# Addendum 001

## Additional and Revised Information for Bidders

Project Name: HACN Will Rogers Senior Living Apartment Elevator      Original Issue Date: 11-10-2017  
Project Address: 202 E Stuart Roosa, Claremore, OK 74017      Revision Date: 03-28-2018  
Project Number: 01-1708  
Owner: Housing Authority of the Cherokee Nation      From: TriArch PLLC  
Attn: Duane White      Mark Gawey  
Dwight Tyner      Evelyn Junco

5 ELEVATOR PIT SECTION  
3/4" = 1'-0"

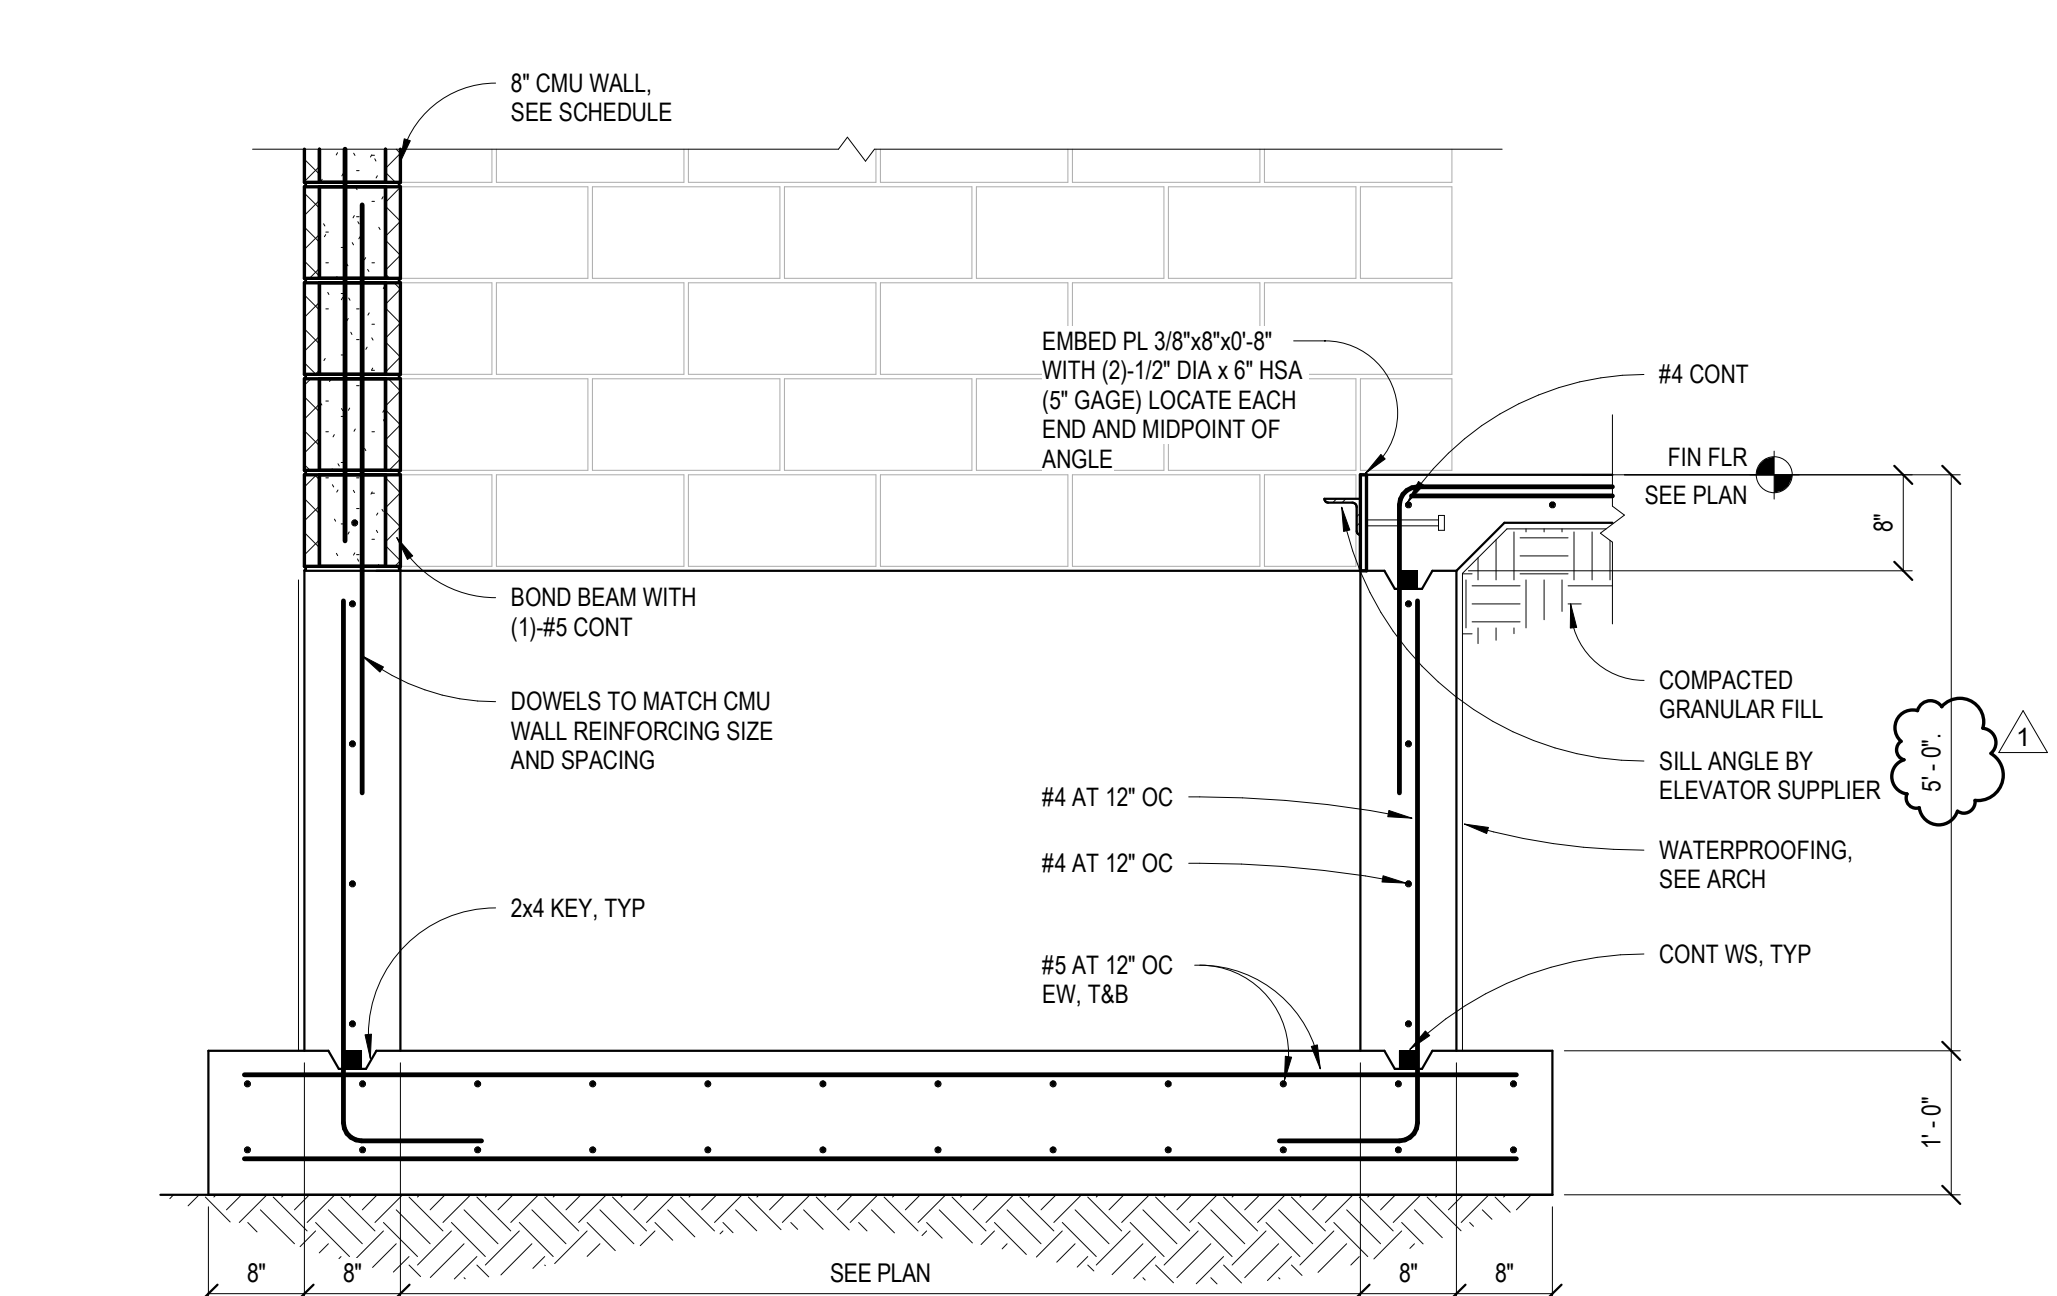
**Item A1-2.** Revise sheet S501- Details

1. Drawing 5, Elevator Pit Section: change pit depth to 5'
